# **TOWN OF PARADISE VALLEY**

## **Paradise Valley DoubleTree Resort Minor Special Use Permit Amendment 5401 N Scottsdale Road Public Meeting**

Planning Commission  
June 16, 2026

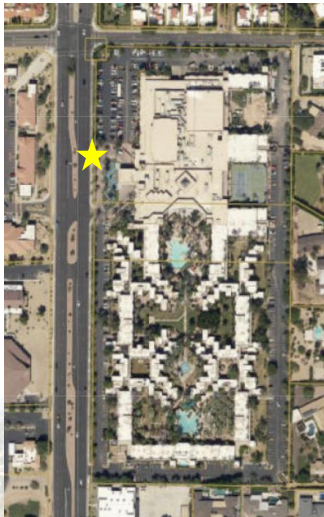
- Items discussed (Continued)
  - Review of the proposed and edits to certain existing stipulations – included removal of the 850-person local function cap from 1985 supported by the parking study. Also, the removal of the 4-foot-tall lighting - lighting plan included with SUP-25-04 and modification requires applicable SUP amendment
  - Provide site address on the entry sign(s), perimeter wall, or other visible location – revised

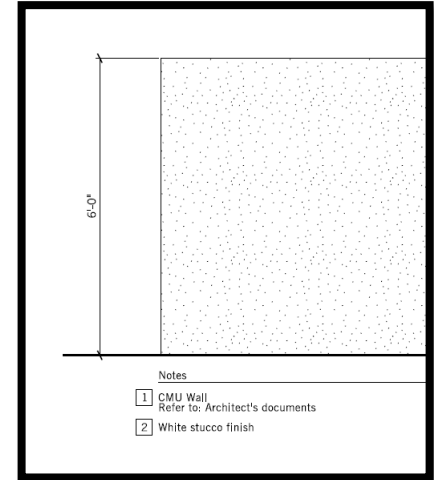
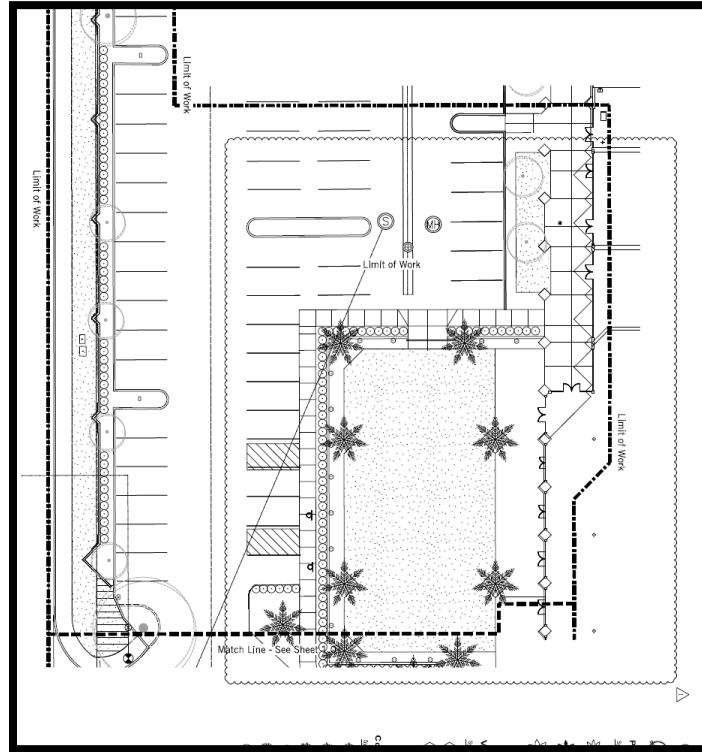
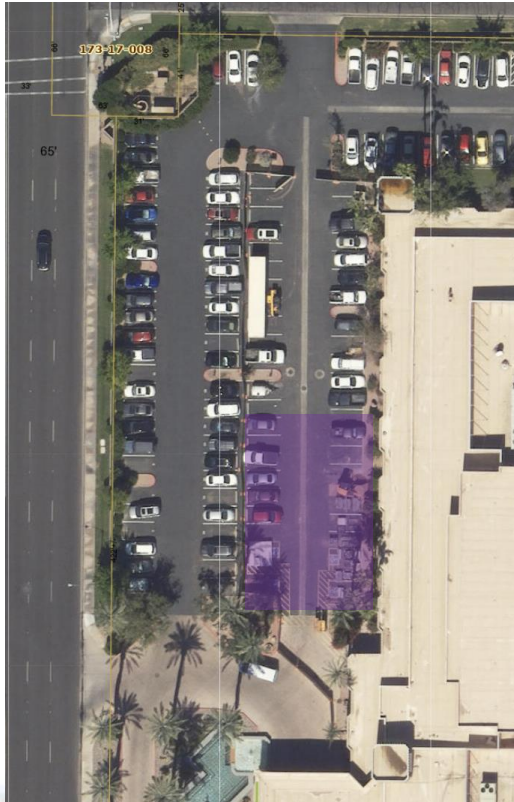
- Items discussed (continued)
  - Encouragement to match that the new 6-foot-tall block white stucco wall approved in SUP-25-04 located between the two driveways along Scottsdale Road with the existing white shade and block of the existing perimeter wall
  - Applicant will try to prepare a conceptual visual for the June 16<sup>th</sup> meeting
  - Stipulation 7 added
    7. The screen wall located between the two driveways along Scottsdale Road west of the porte-cochere will incorporate materials complementary to the primary resort buildings and walls (e.g. masonry, stucco, shade of color).

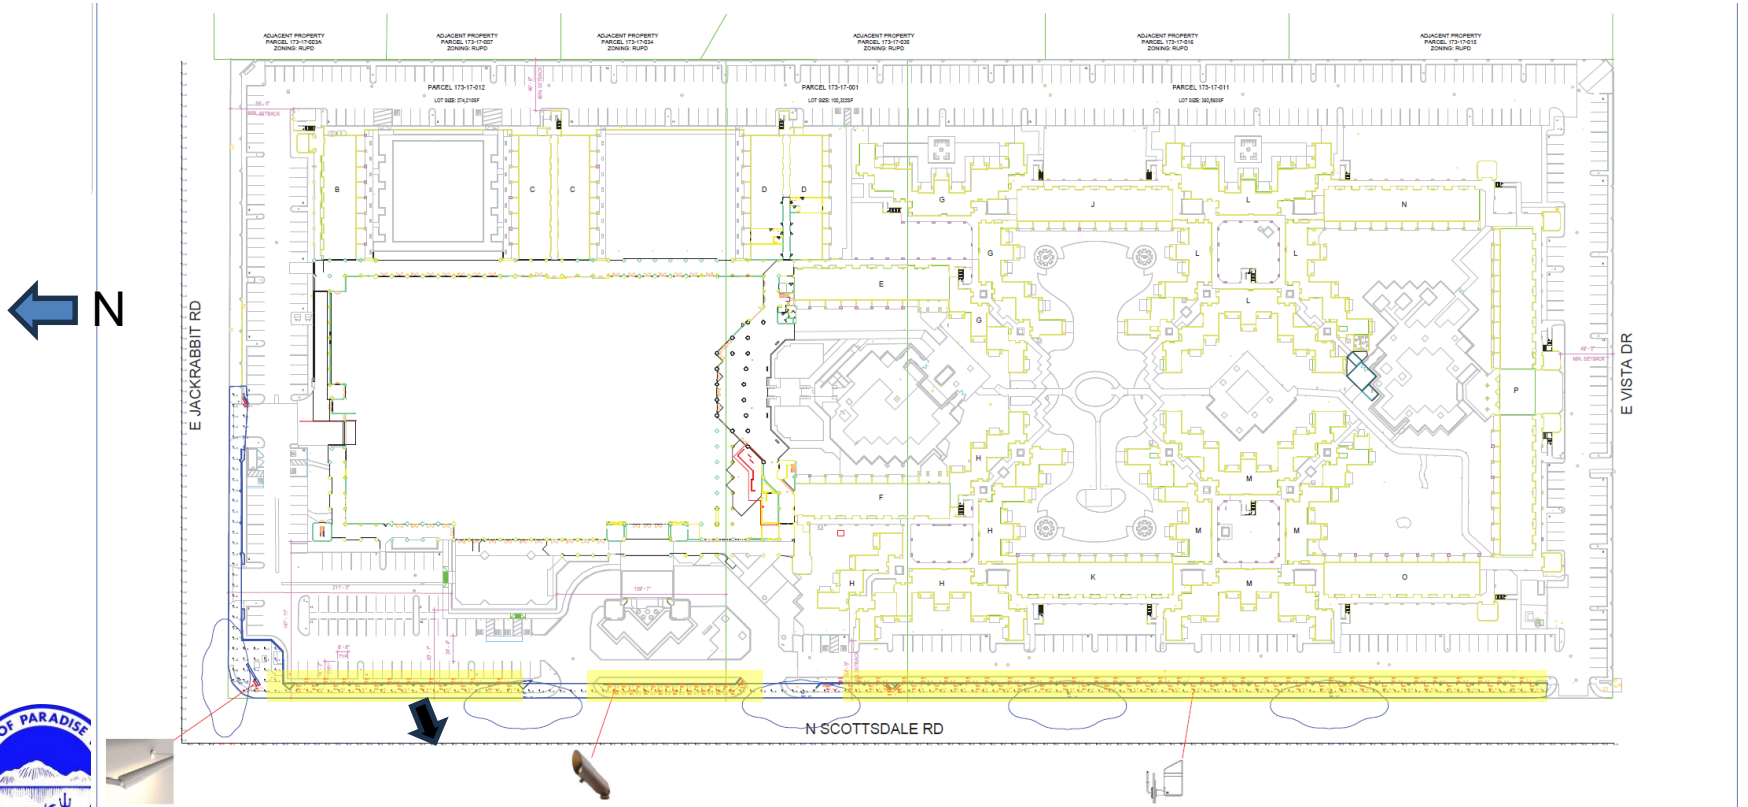
- Add accent wall lighting along Scottsdale Rd
  - Spaced approximately 20 feet apart
  - Mounted on perimeter wall
  - No lights to be in the right-of-way
  - Applicant to provide conceptual images for meeting

3.f All accent lighting of the perimeter wall along Scottsdale Road shall not be within the right-of-way. Such lights shall be architecturally integrated onto the wall without increasing the existing wall height over the provisions of Chapter XXIV, Walls and Fences, of the Town's Zoning Ordinance, shall not exceed 300 lumens if directed upwards (and 400 lumens if angled or downward facing), have not more than 3000 Kelvins, and be hooded and shielded. No perimeter wall lighting shall be allowed along Jackrabbit Road.
